Attorney's Docket No.: 07326-002003

Amendments to the Drawings:

Page 1 of 2  
MODULAR COMPUTER SYSTEM  
Scott Lochner et al.  
09/994,520  
07326-002003  
ANNOTATED SHEET

FIG. 3

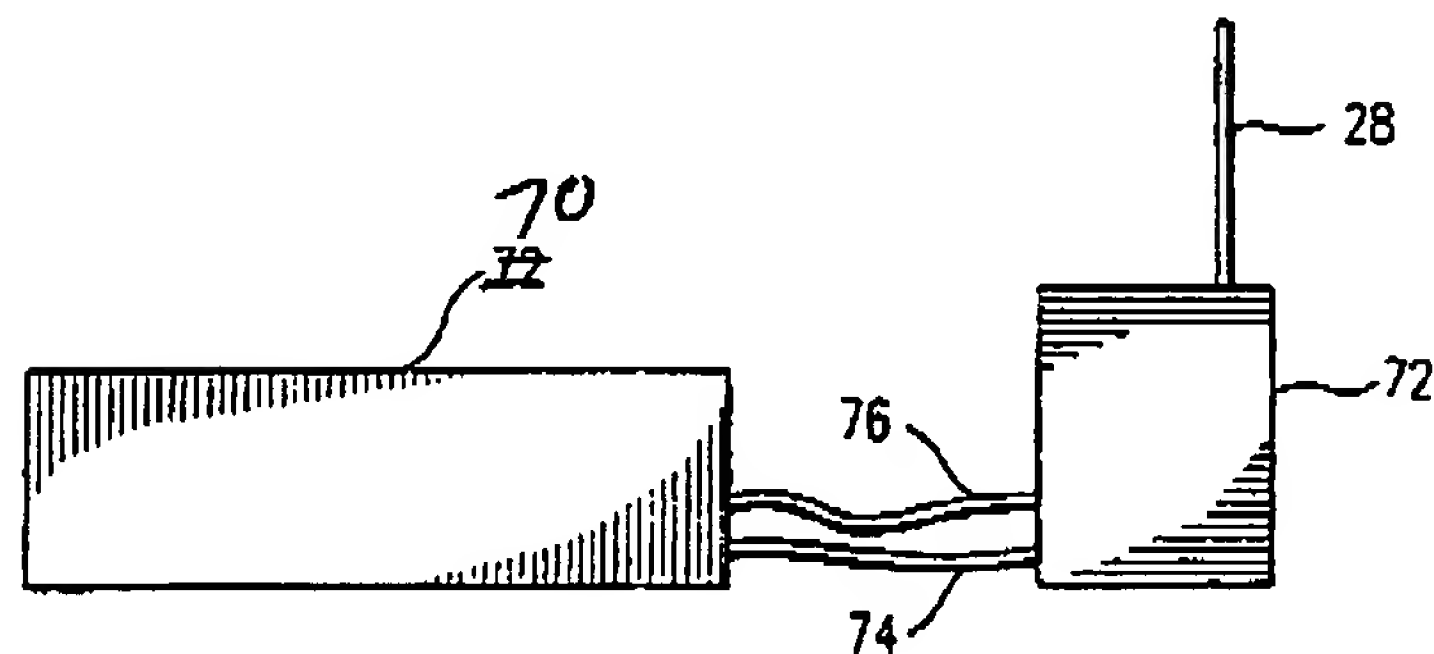
Figure 3 has been amended to properly recite the unit 70.

The drawings stand objected to under Rule 1.83(a). The video generation unit, and a notation that the video represents "n bits", has been added to Figure 2. Figure 3 has been amended to properly show the "unit 70".
